UNITED STATES ENVIRONMENTAL PROTECTION AGENCY
REGION 5
77 WEST JACKSON BOULEVARD
CHICAGO, IL 60604-3590

Re: EPA's response to Tecumseh Products Company's September 30, 2013 Supplemental Submission to the Human Exposure Environmental Indicator Report (MID005049440)

Attachment – Investigation Deficiencies & Required Actions

Figure 2: Interpretation of Northern Plume Migration from Assessment Data

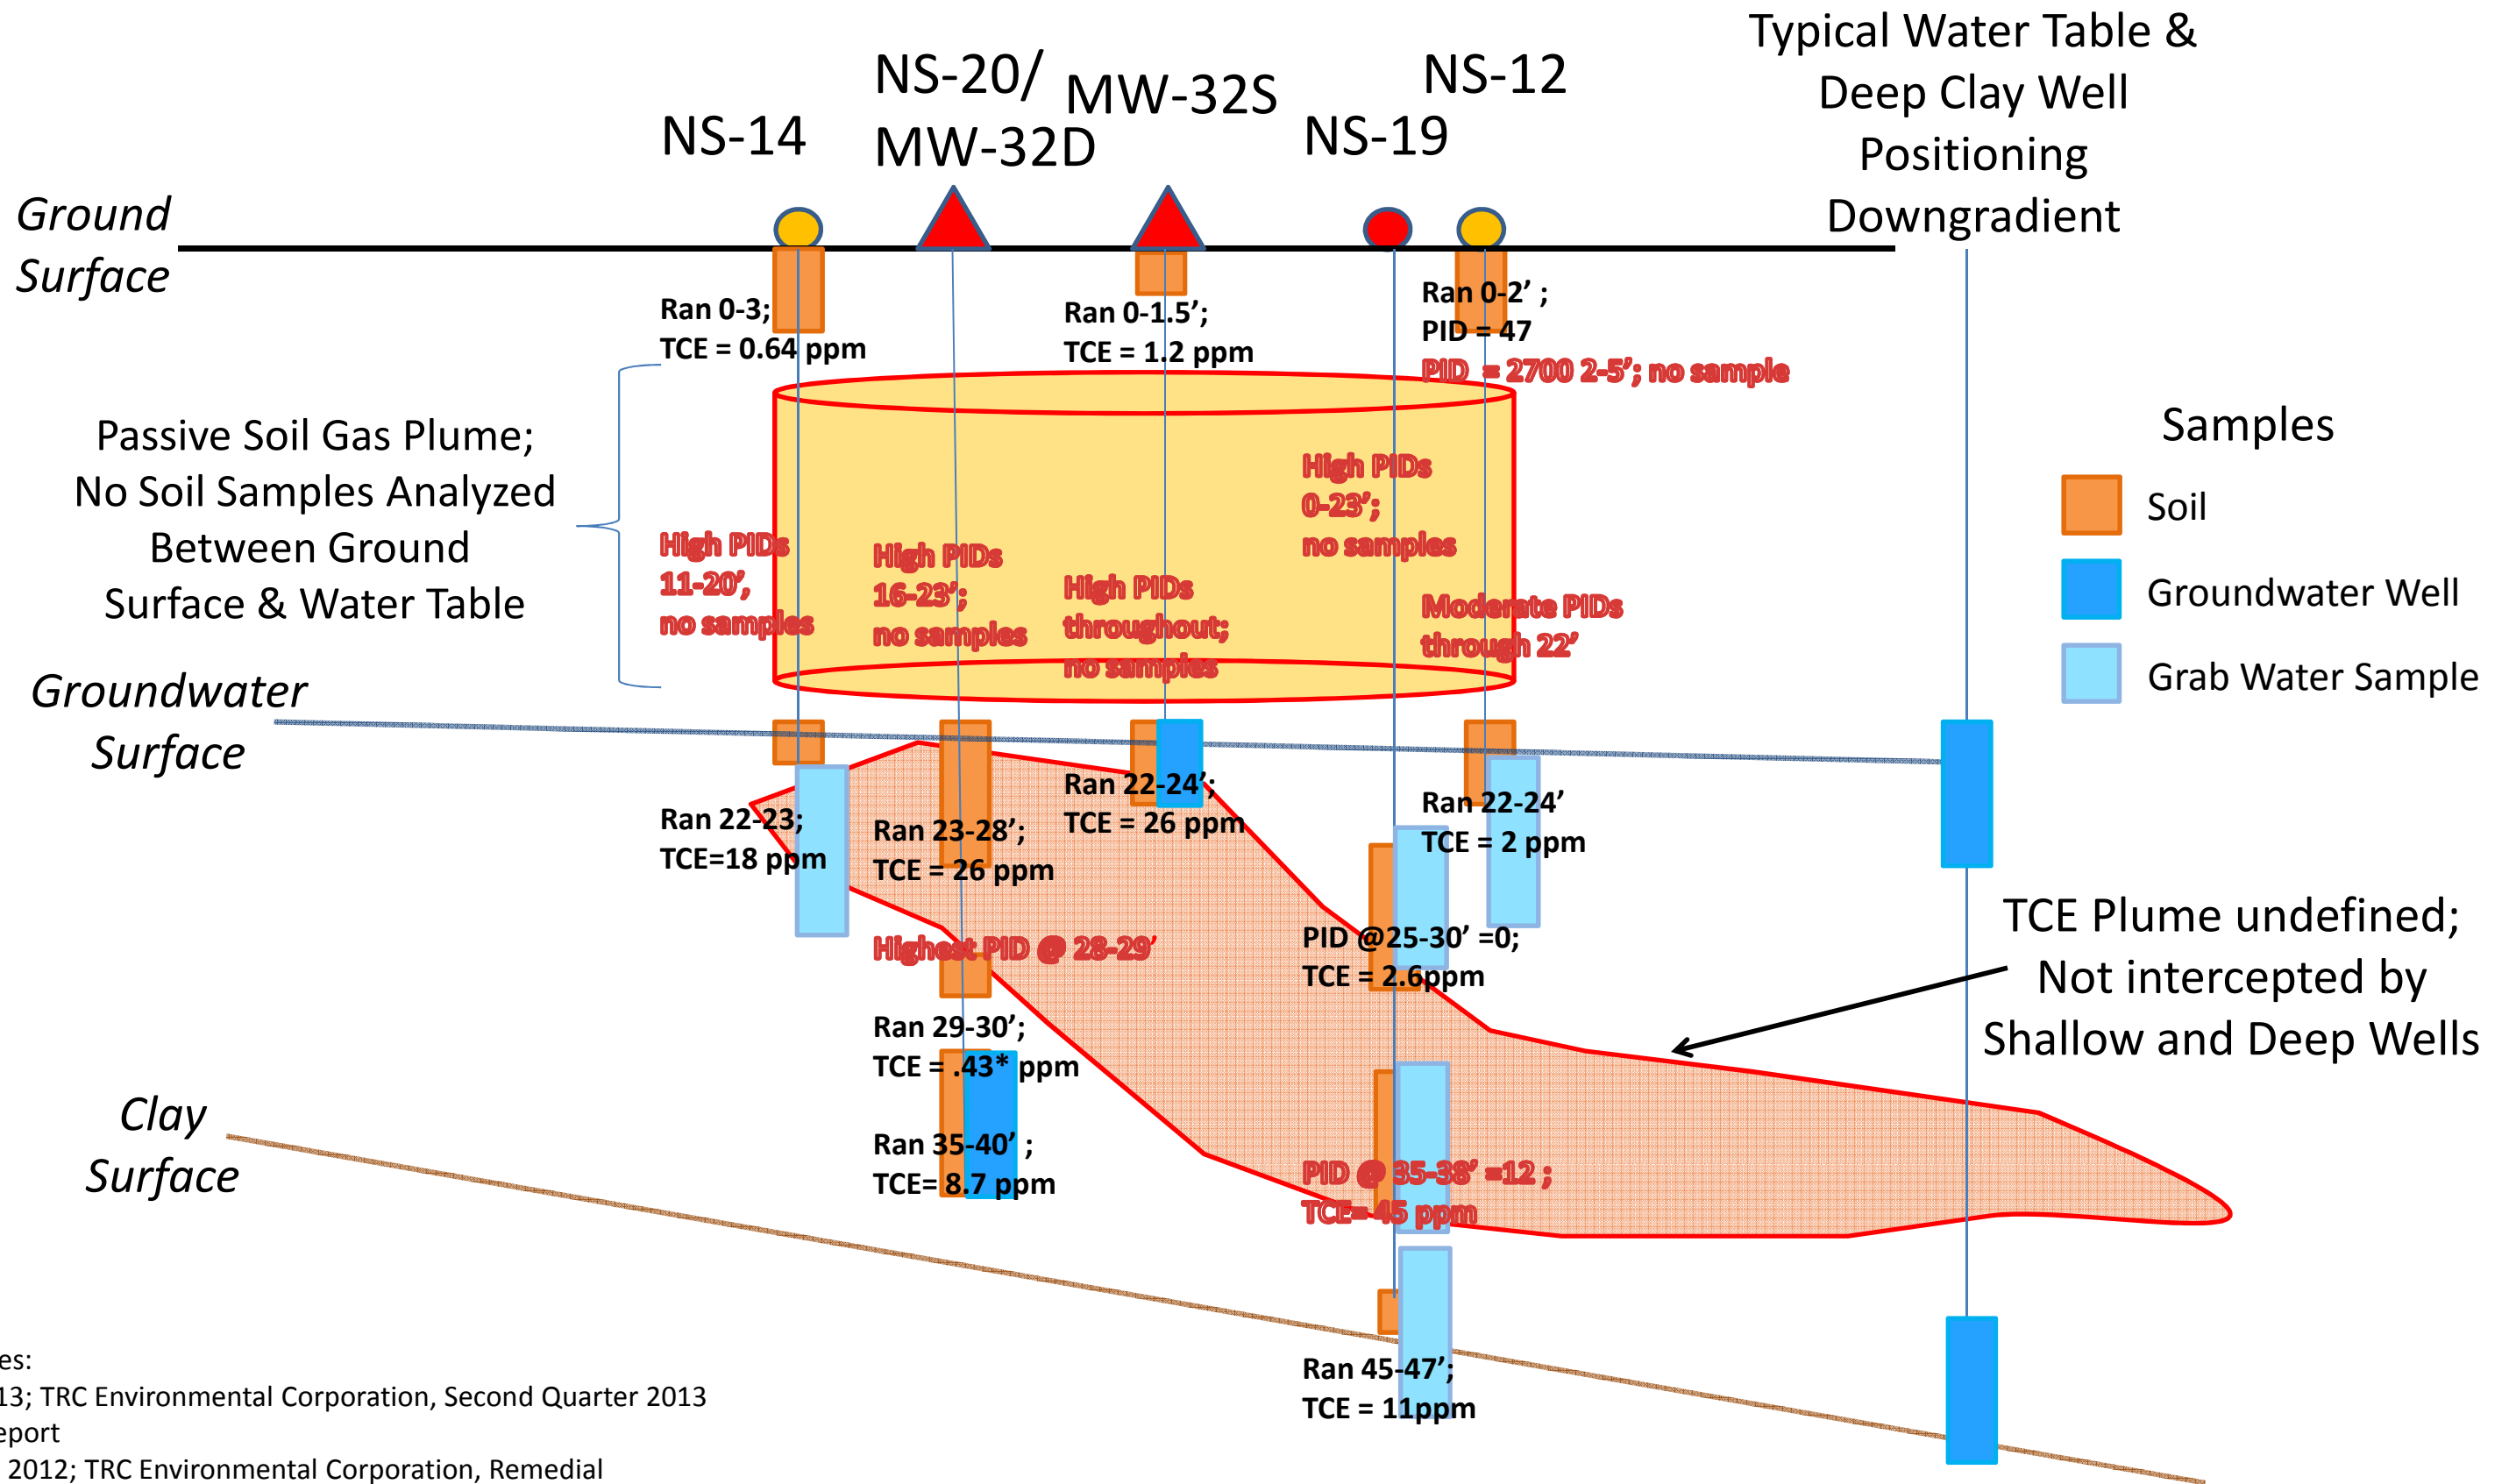
- Soil sampling targeted primarily only two intervals: the shallow soil (0-4 feet), and the water table (approximately 20-22 feet), leaving the majority of the soil column unassessed and the vertical distribution of contaminants undetermined and undelineated (*see*, **Figures 2 & 3**).

- Soils between the ground surface and water table with high field screening results were not analyzed, potentially resulting in a selection bias towards lower concentrations, and leaving exceedances of Csat undetermined. Refer to sampling from NS-12 for an example, in which case the sample from 0-2 feet was analyzed where the PID reading was 47 ppm, instead of the sample from 2-5 feet where the PID reading was 2,700 ppm. Concerns related to a potential selection bias towards low concentrations for soil sampling are highlighted on **Figure 2**, and shown in the cross section in **Figure 3**.

- The figures developed by EPA using TPC's field screening data and sampling results show an apparent lack of delineation across the two source areas near NS-18 and NS-19 (*see*, **Figure 2**).

- Delineate the impacts with increasing depth and distance from the source areas following the apparent pathways of migration. Soil borings should be positioned to follow contaminant migration to depth in both the direction of the dip of the deep clay surface, and in the direction of groundwater flow after the depth of heaviest impacts has been determined (*see, Figure 2*).

intervals and higher concentrations than those being monitored, and potentially at deeper intervals west of MW-2S (*see*, **Figures 1 & 2** for interpreted plume paths).
